Dam Safety Inspection Report

DAM: LAKE CHARMAINE DAM

OWNER: CITY OF IVANHOE

CURRENT INSPECTION DATE: 6/14/2017

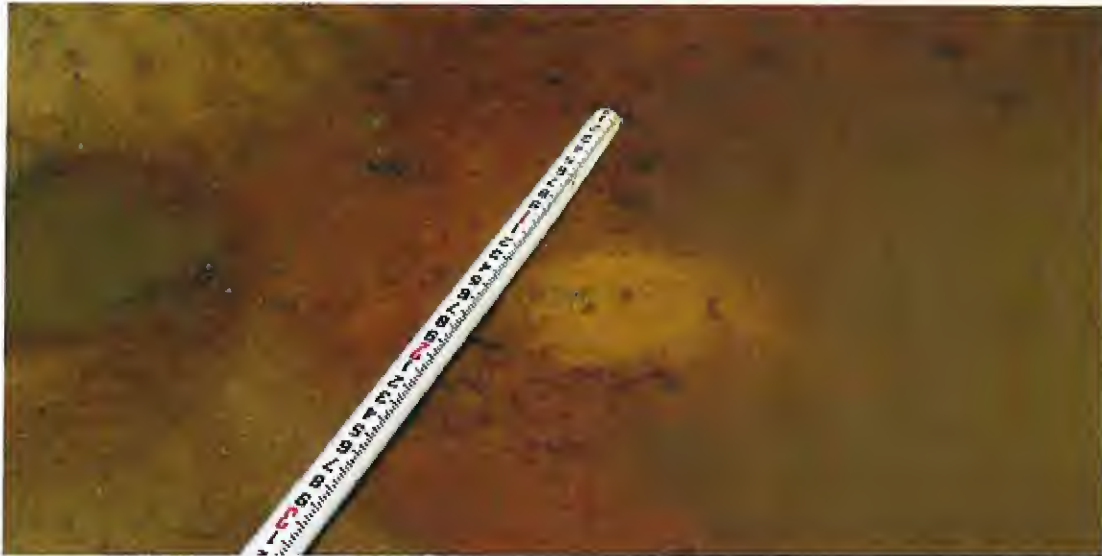
- At least one boil was identified in the same general location of the stilling basin as had been noted in past inspections. Mr. Harrison stated that there were now less boils than before the grouting project was completed.
- Heavy unwanted vegetation was noted to be growing around the stilling basin area.

Photo #19 – View of bubbling occurring at a boil located in sediment at the stilling basin just downstream of the concrete slope. Boils, which were noted during the last inspection, were also observed during this inspection. However, there did not appear to be as many or as large as noted in the previous inspection.

- b) Remove silt from the stilling basin area and monitor the inflow of new silt and quantity and condition of boils as they re-appear. Locations of the boils should be recorded with dates and quantity of sediment removal.
